11.1.16 Proposed Concrete Batching Plant - Amended Plans to Approved Application - Section 31 SAT Reconsideration

Location: Lot 2, 277-279 Collier Road, Bayswater
Applicant: WA Limestone
Owner: Ransberg Pty Ltd
Officer: Director Planning and Development Services
Refer: Item 11.1.10: OCM 25.8.2015
 Item 11.1.10: OCM 26.5.2015
 Item 11.1.12: OCM 23.7.2013
 Item 11.1.10: OCM 23.4.2013
 Item 15.1.3: OCM 22.11.2011
 Item 11.1.12: OCM 28.6.2011

**Proposed concrete batching plant - WA Premix
SAT mediation - updated advice on environmental risks**

**Plans for Development - Approved and Amended
Overlay**

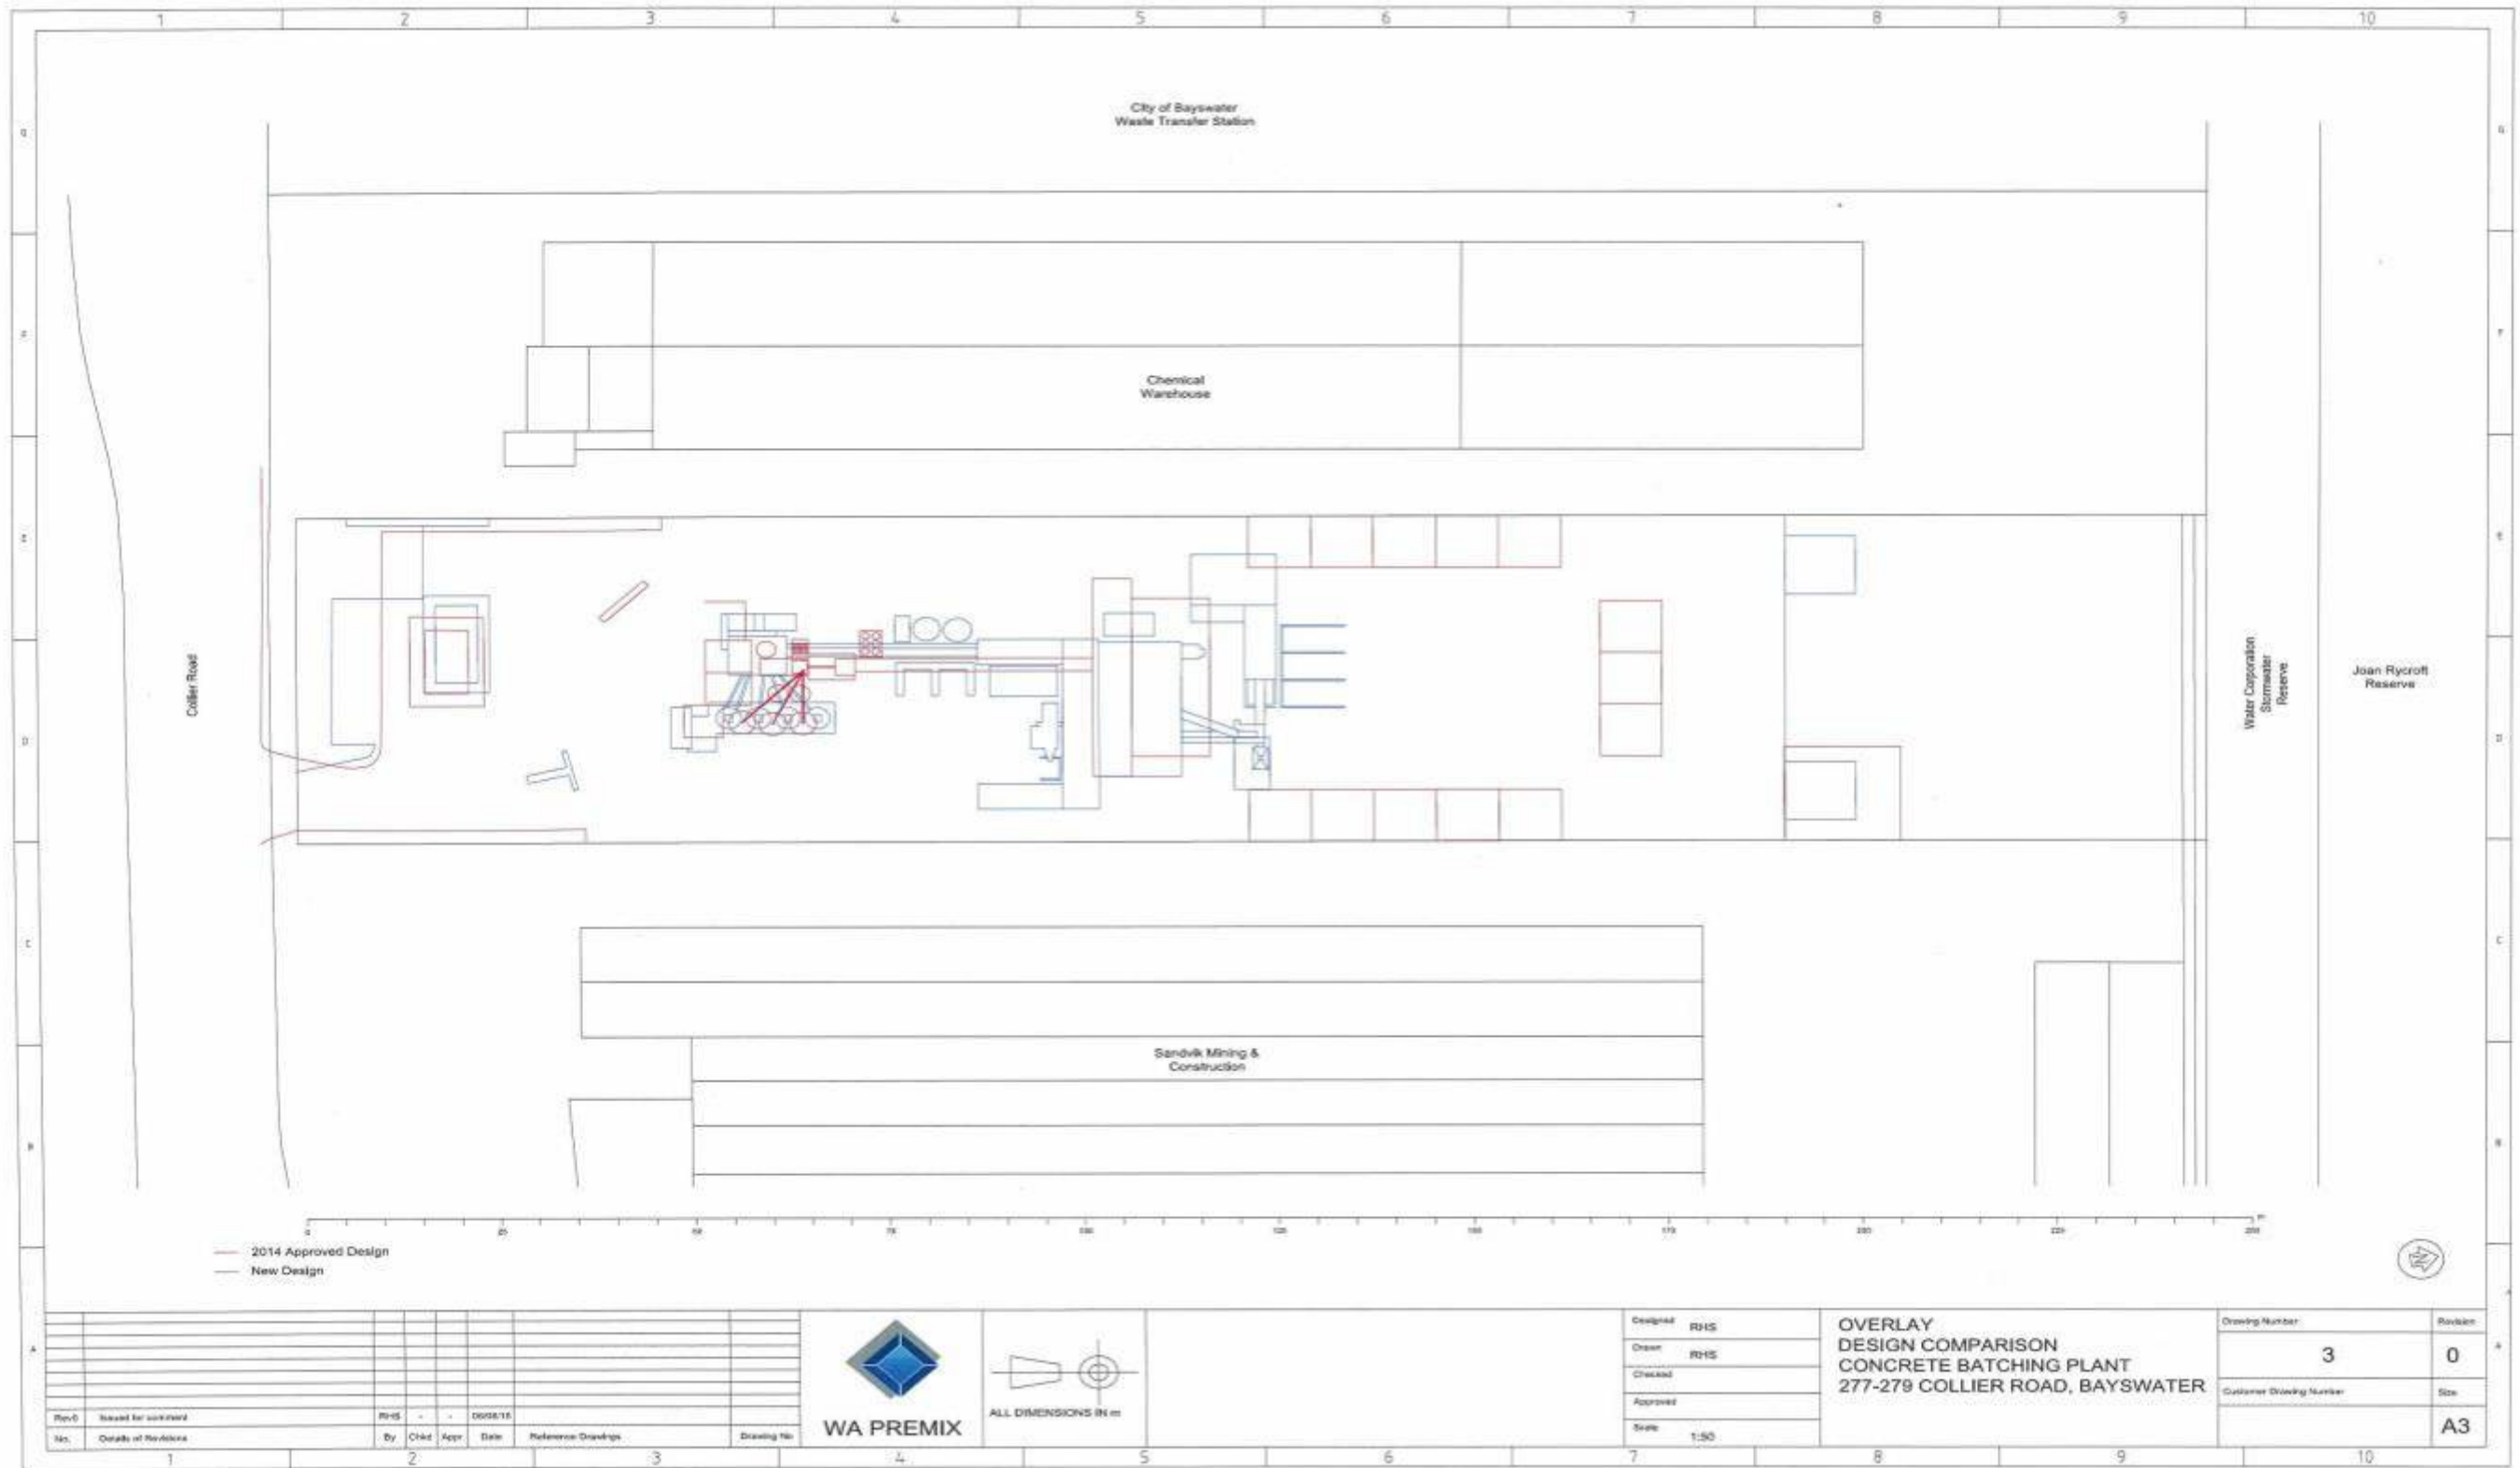
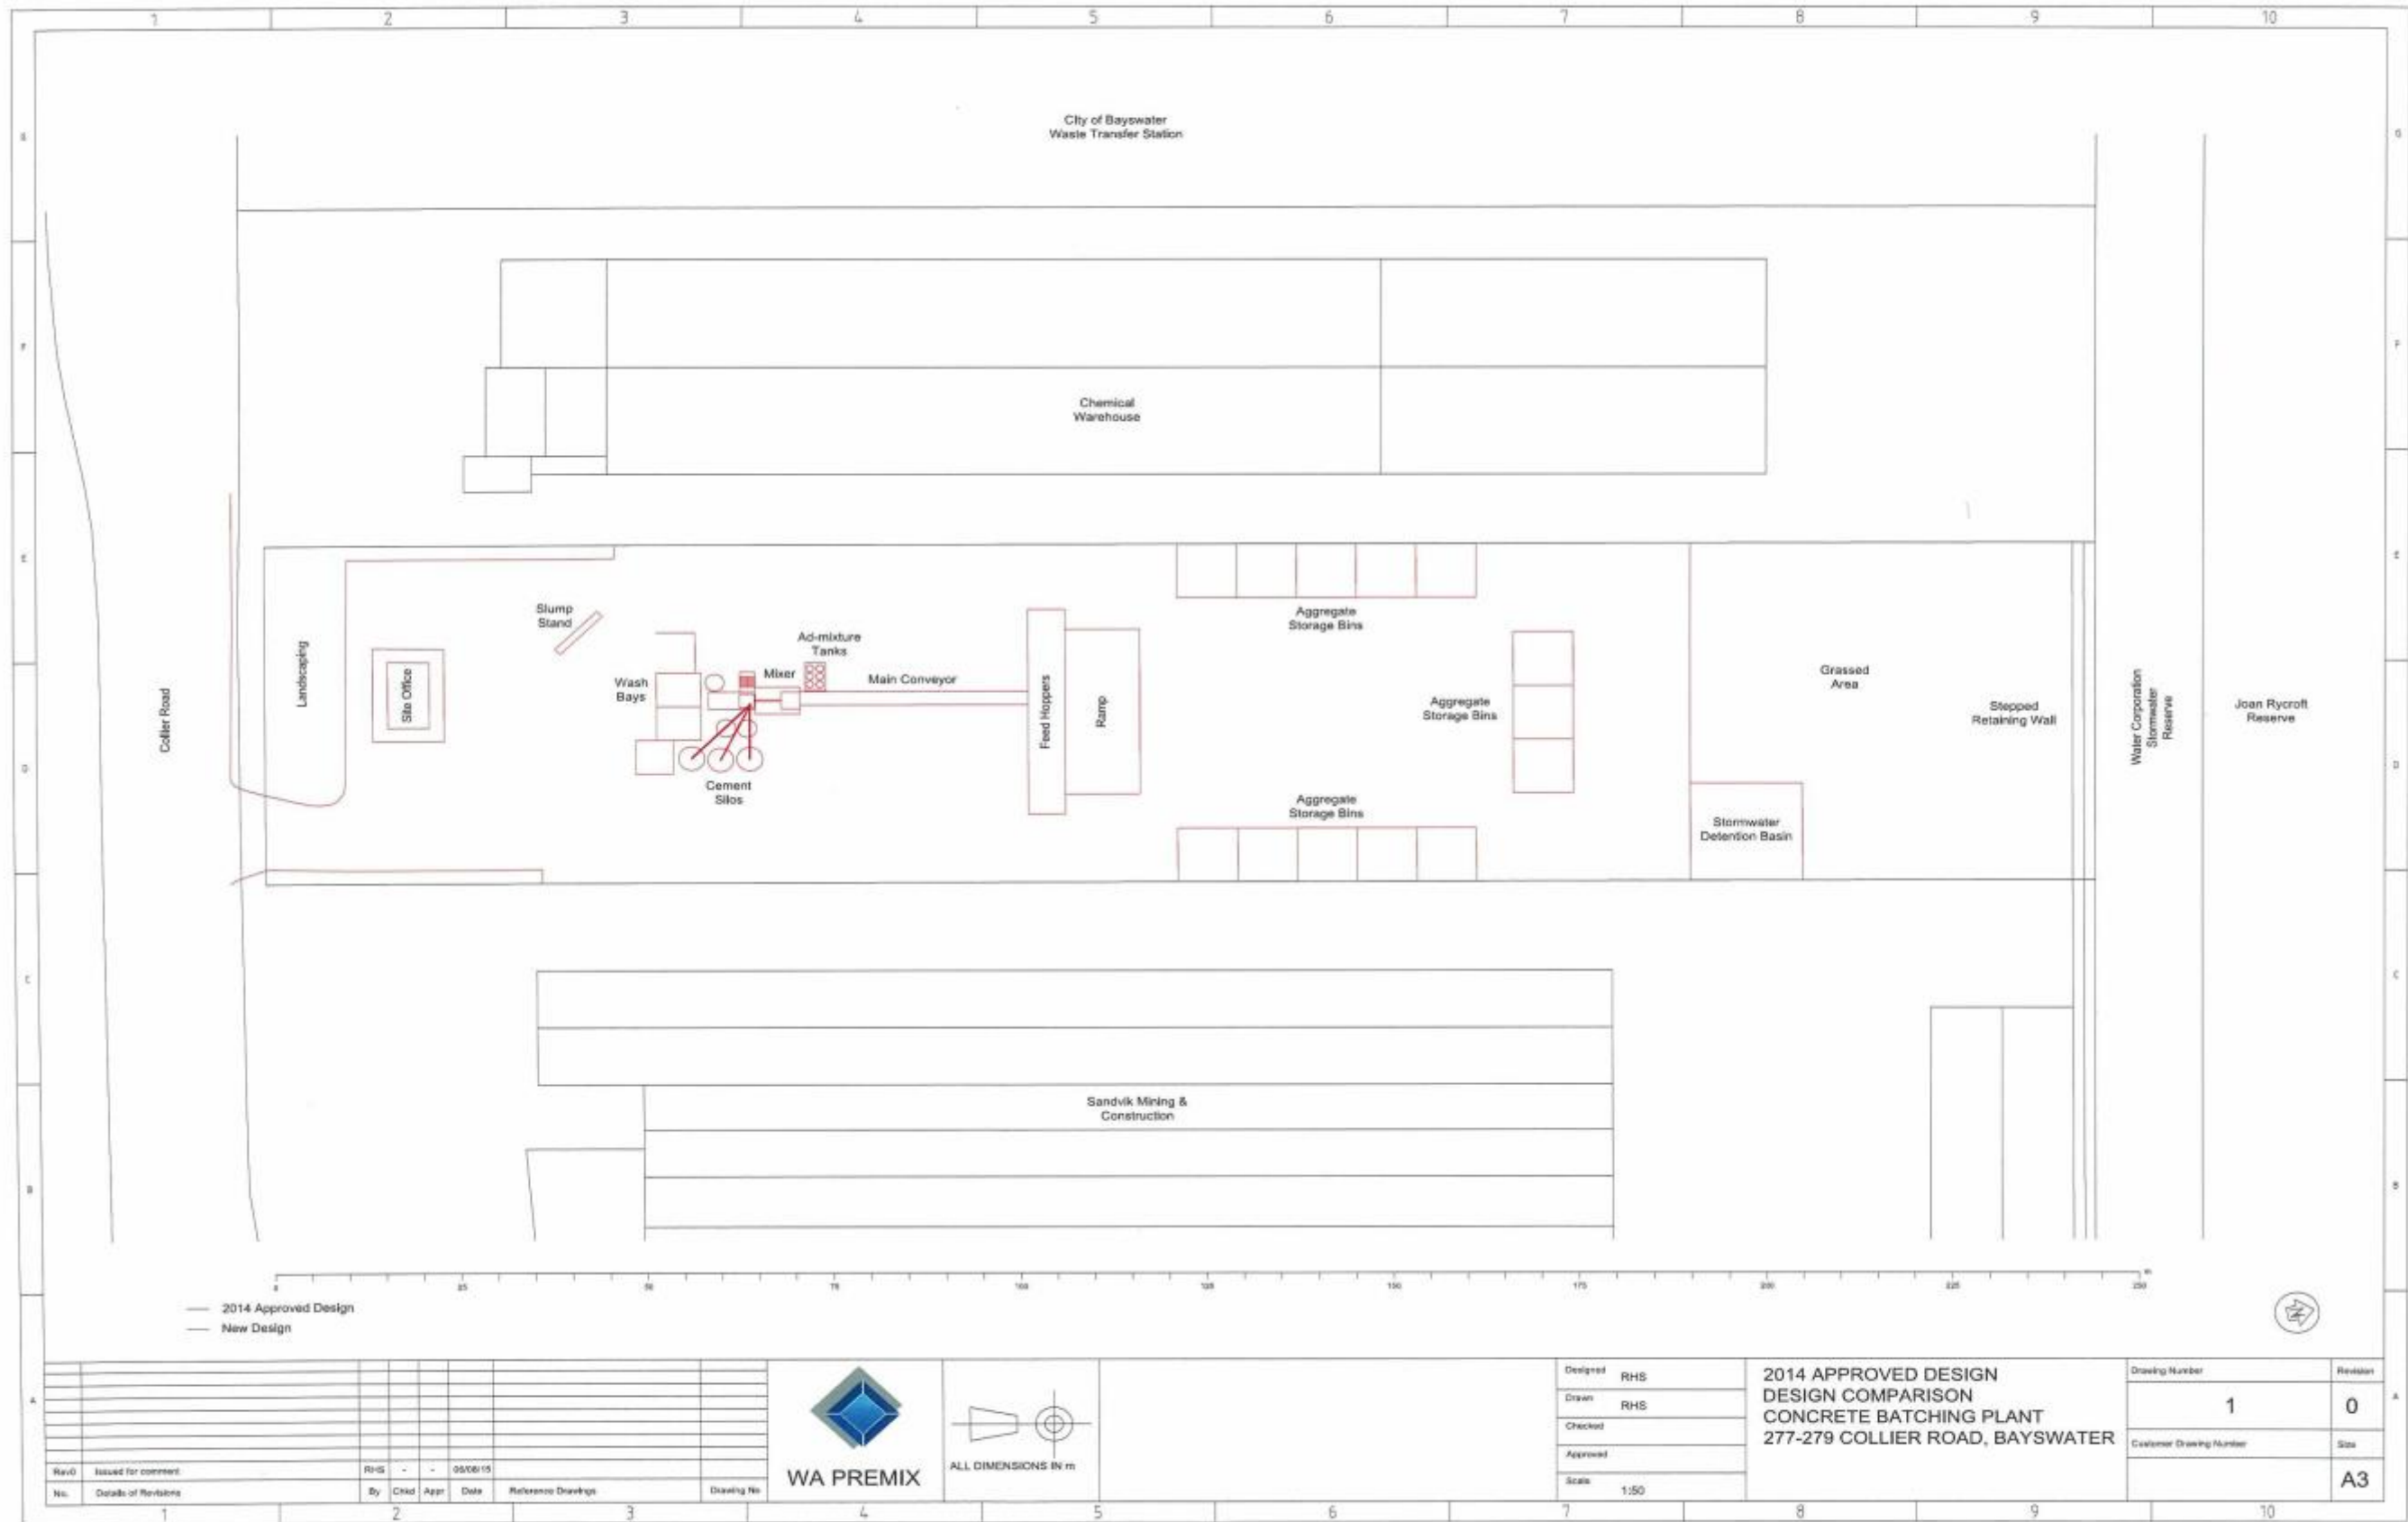
The proposed alterations are considered to improve the applicant's ability to manage dust and noise emissions from the site, given the plant will be mostly enclosed. The amended plans will essentially eliminate the consistent use of front-end loaders which is considered to substantially lower any potential noise impacts.

The original approved SAT application and the amended plans are for a wet-mix plant which is considered to pose less of a risk relating to dust emissions when compared to a dry-mix concrete batching plant. Not only is a wet-mix batching plant considerably better at reducing dust emission than a conventional plant, the amended proposal includes mostly enclosed areas of the process as part of the amended plans. The environmental consultant has advised this process and associated amendments are considered to dramatically reduce impacts relating to dust generation.
